1901 Gratiot Street, St. Louis

ULNRC-1747

DOCKET NUMBER 50-483
CALLAWAY PLANT
REVISION TO TECHNICAL SPECIFICATION 3/4.7.6
CONTROL ROOM EMERGENCY VENTILATION SYSTEM

FIGURE-1
SIMPLIFIED SCHEMATIC OF
CONTROL BUILDING VENTILATION

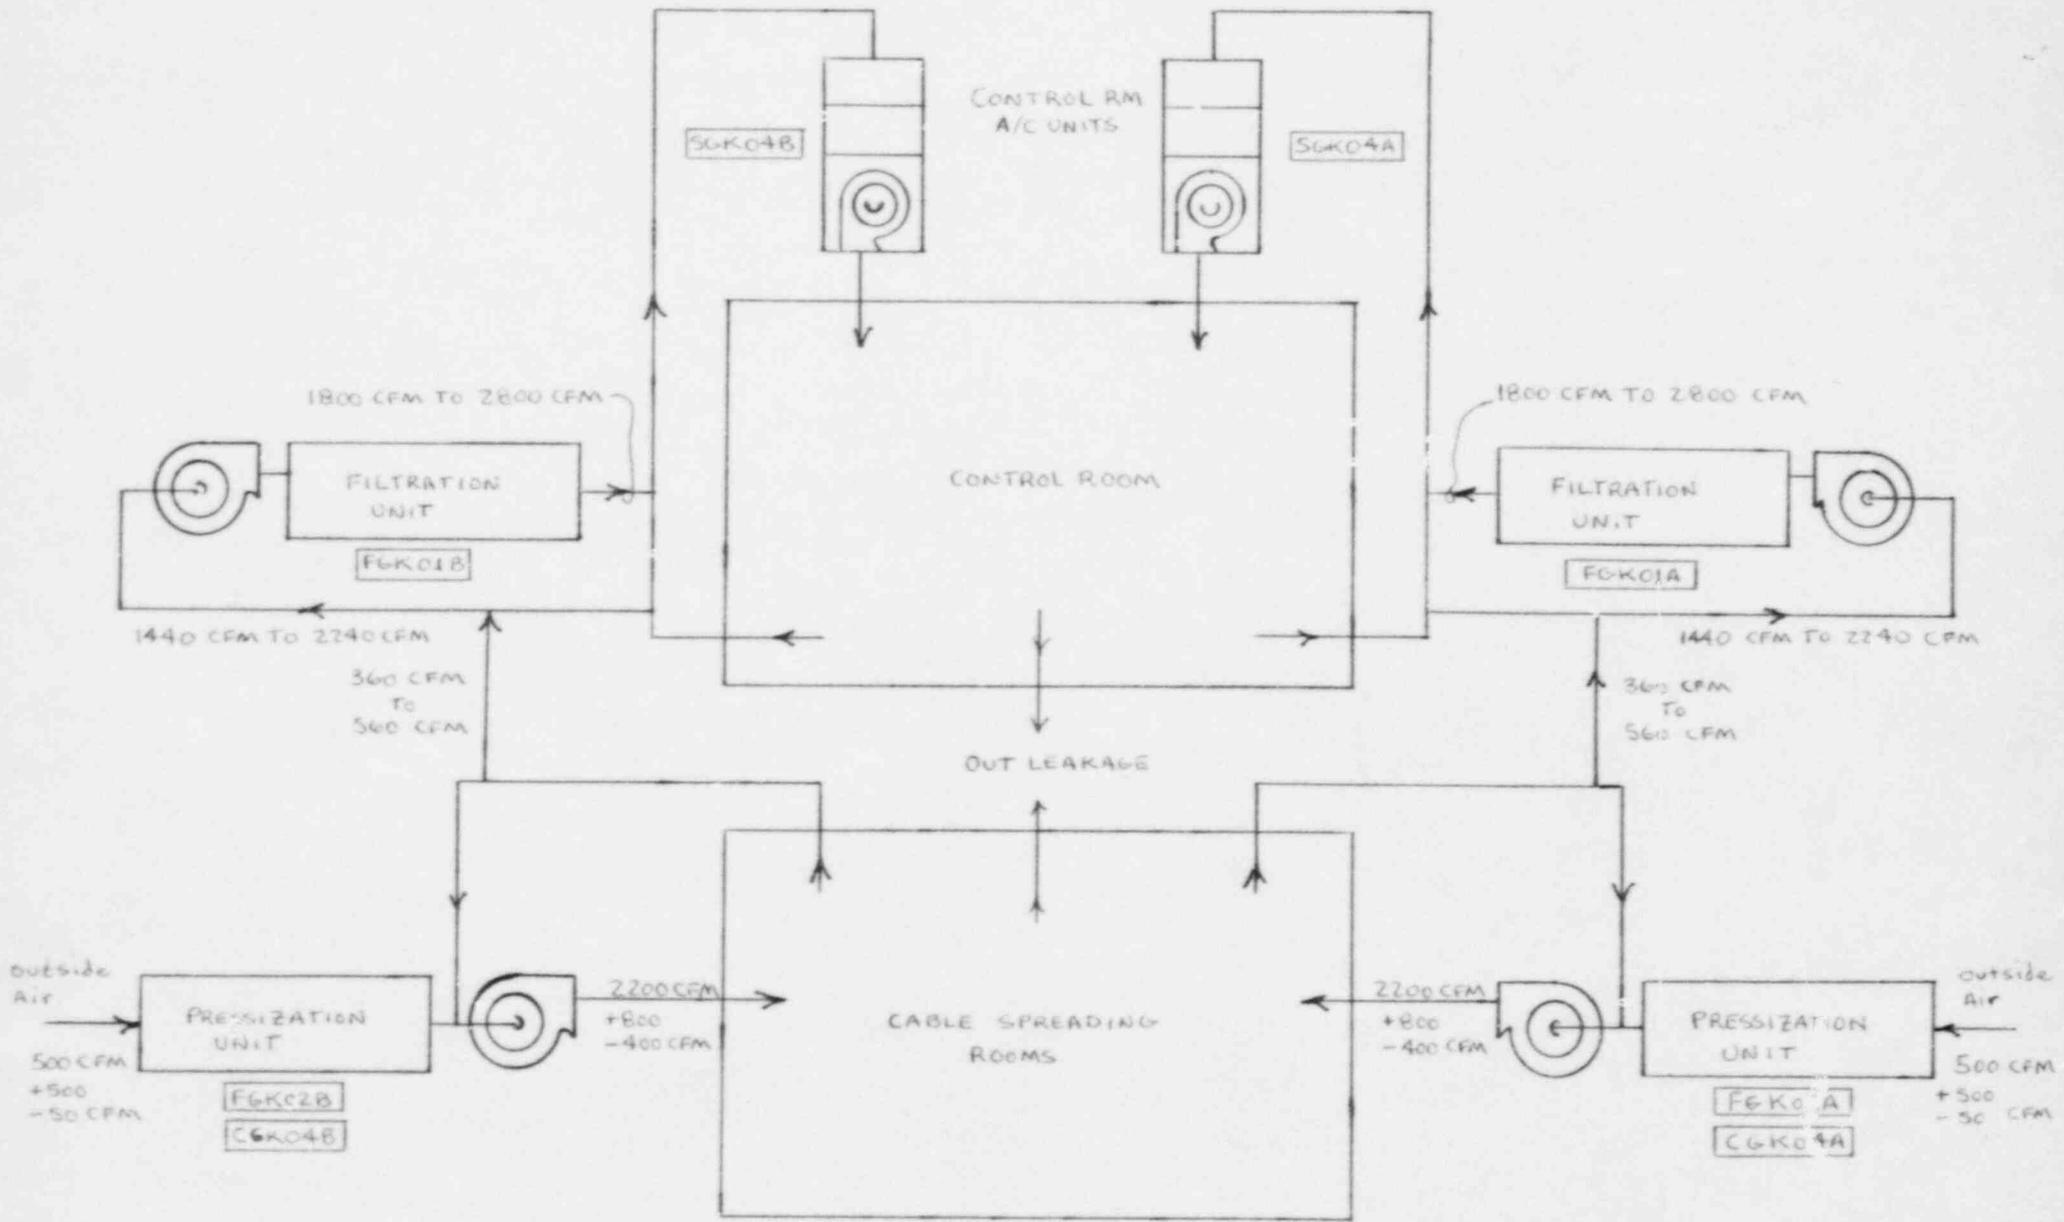
During the emergency mode of operation, the control room normal ventilation system is secured, and all air flow paths into and out of the control room, except for the emergency ventilation system, are isolated. The control room ventilation isolation signal also automatically bypasses portions of the control room air-conditioning system flow through the associated particulate filter/charcoal adsorber train for cleanup and initiates operation of the control room pressurization system. The control room pressurization system draws in outside air, processing it through a particulate filter/charcoal adsorber train for cleanup. This outside air is diluted with air drawn from the cable spreading rooms and the electrical equipment floor levels and distributed back into those spaces for further dilution. The control room filtration system takes a portion of air from the exhaust side of this system, upstream of the outside air intake, for dilution with portions of the exhaust air from the control room air-conditioning system and processes it through the control room filtration system adsorption train for additional cleanup. This air is then further diluted with the remaining control room air-conditioning system return air, cooled, and supplied to the control room. This process will maintain the control room under a positive pressure assuring exfiltration from the control room, thus preventing any unprocessed contaminants from entering the control room. See Figure 1 for a sketch of the system flow paths.
